HARTZELL PROPELLER INC.
SERVICE BULLETIN
HC-SB-61-393
Propeller Mounting Nut/Torque Inspection

- (1) In Hartzell Propeller Inc. Owner's Manual 486 (Rev. 2), the part number for the propeller mounting nut and the associated torque value were listed incorrectly for the affected propellers.

- (1) This Service Bulletin provides Instructions for Continued Airworthiness (ICA).
- (2) This Service Bulletin corrects the propeller mounting nut part number and torque specification that was previously published in Hartzell Owner's Manual 486 (Rev. 2).
 - (a) Refer to the Material Information section of this Service Bulletin for the propeller mounting nut part number and the applicable torque value.
- (3) This Service Bulletin provides instructions for a "Mounting Nut Torque Inspection" for the affected propellers.
 - (a) Hartzell Propeller Inc. will warrant the labor costs associated with the "Mounting Nut Torque Inspection" when performed in accordance with the Accomplishment Instructions section in this Service Bulletin.
 - 1 Refer to the Appendix section of this Service Bulletin for additional information about the warranty program.

107595 Mounting Nut Identification
Figure 1

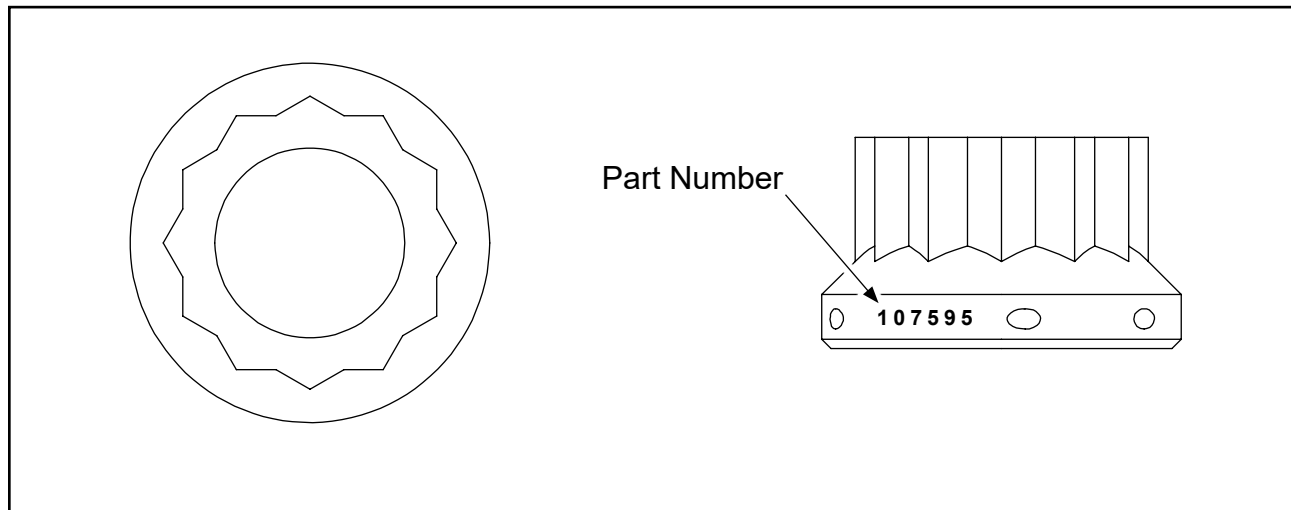
- (a) In Manual 486 (Rev. 2), Table 3-1 ("Propeller Mounting Hardware") listed the propeller mounting nut as p/n C-6006.

1 The mounting nut used on the affected propellers is p/n 107585.

NOTE: All of the affected propellers were packaged and shipped from Hartzell with the 107585 mounting nuts. The part number is stamped on the 107585 mounting nuts as shown in Figure 1 of this Service Bulletin.

**Beta Feedback Block Assembly
Figure 2**

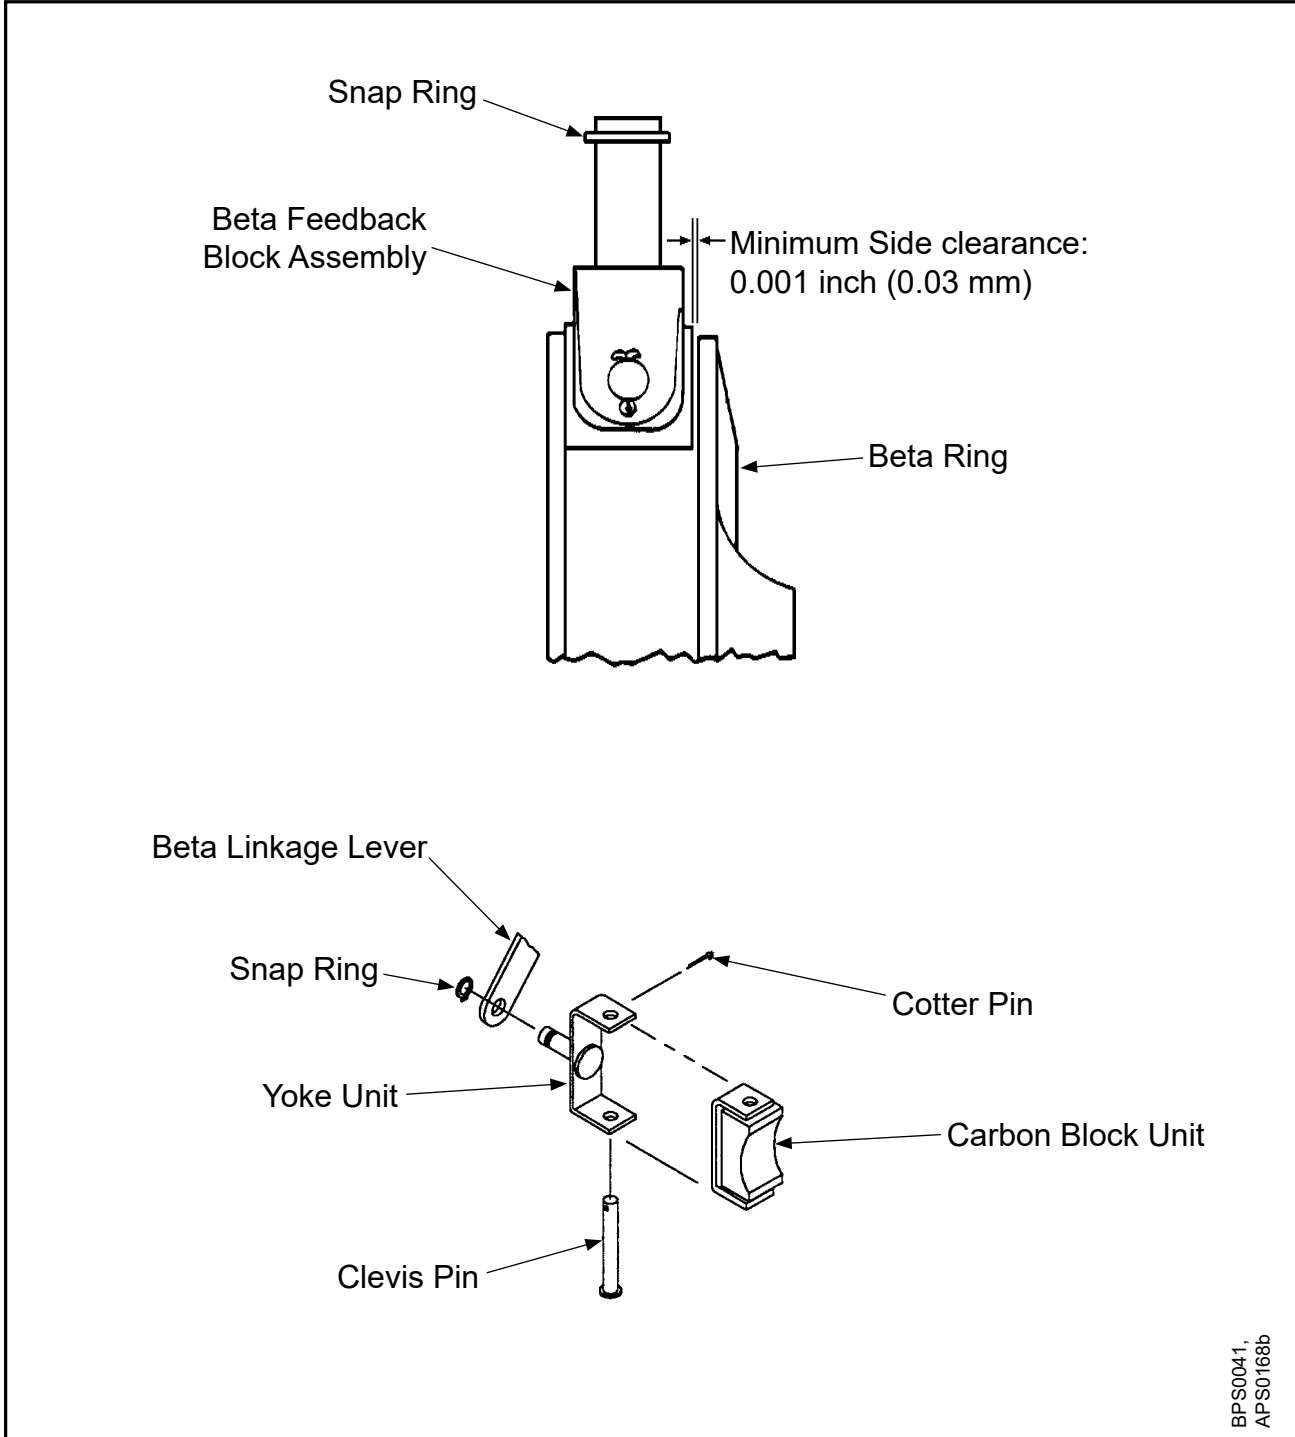
CAUTION: FIT THE BETA FEEDBACK BLOCK ASSEMBLY IN THE BETA RING WITH A MINIMUM SIDE CLEARANCE OF 0.001 INCH (0.03 mm). REFER TO FIGURE 2.

- (9) Install the beta feedback block assembly into the beta ring. Refer to Figure 2.
- (10) Install, adjust, and safety the beta linkage in accordance with the airframe manufacturer's instructions.
- (11) Install the spinner dome in accordance with Hartzell Propeller Inc. Owner's Manual 486 (61-00-86).
- (12) Make an entry in the propeller logbook indicating the "Mounting Nut Torque Inspection" was completed in accordance with this Service Bulletin.

**Torquing Sequence for Propeller Mounting Nuts
Figure 3**

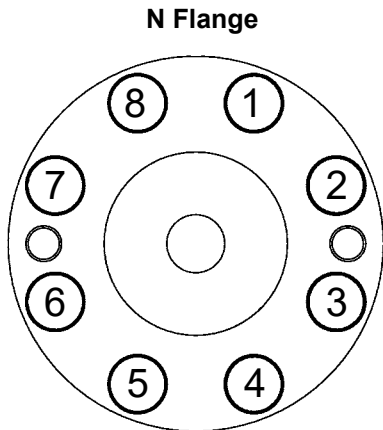
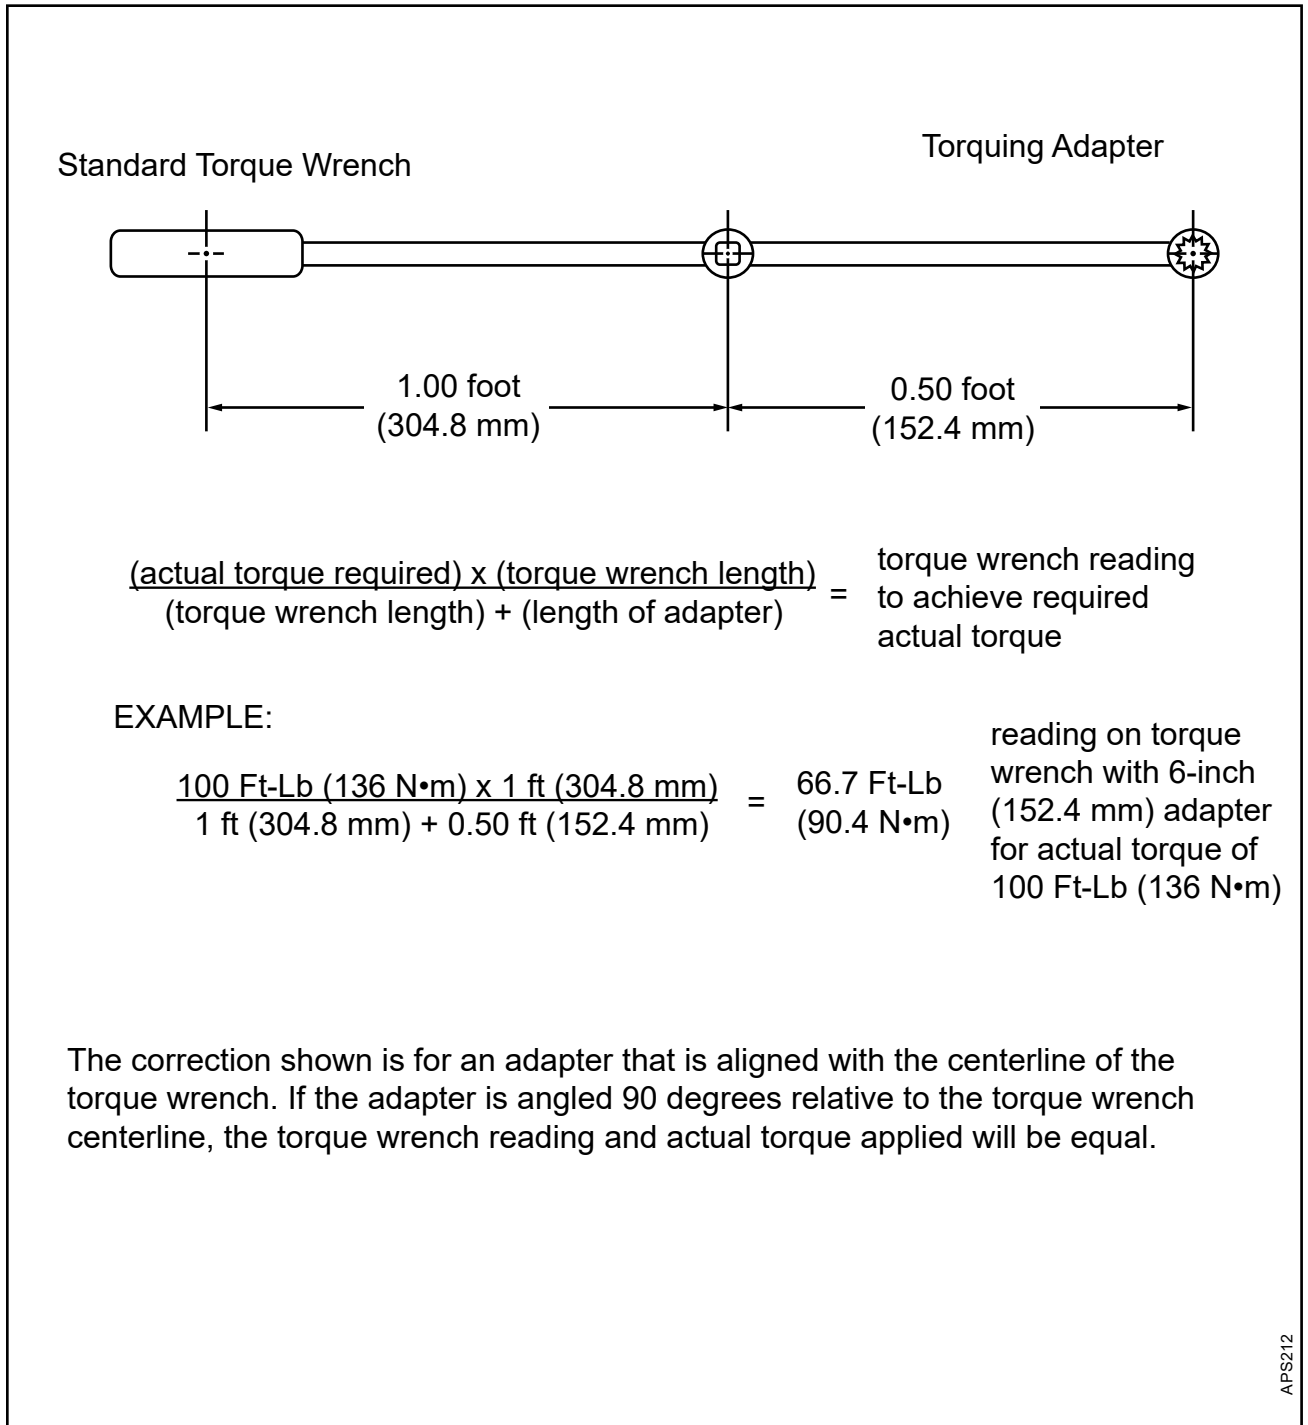
CAUTION 2: REFER TO FIGURE 3 FOR PRELIMINARY TORQUE VALUES AND PROPER TORQUING SEQUENCE FOR THE PROPELLER MOUNTING NUTS.

Propeller Mounting Nut	Final Torque (Refer to Figure 3 for preliminary torque values and the correct torquing sequence)
107585	100-105 Ft-Lbs (136-142 N•m) Wet

Step 1: Torque all nuts to 40 Ft-Lbs (54 N•m) Wet

Step 2: Torque all nuts to 80 Ft-Lbs (108 N•m) Wet

Step 3: Torque all nuts to 100-105 Ft-Lbs
(136-142 N•m) Wet
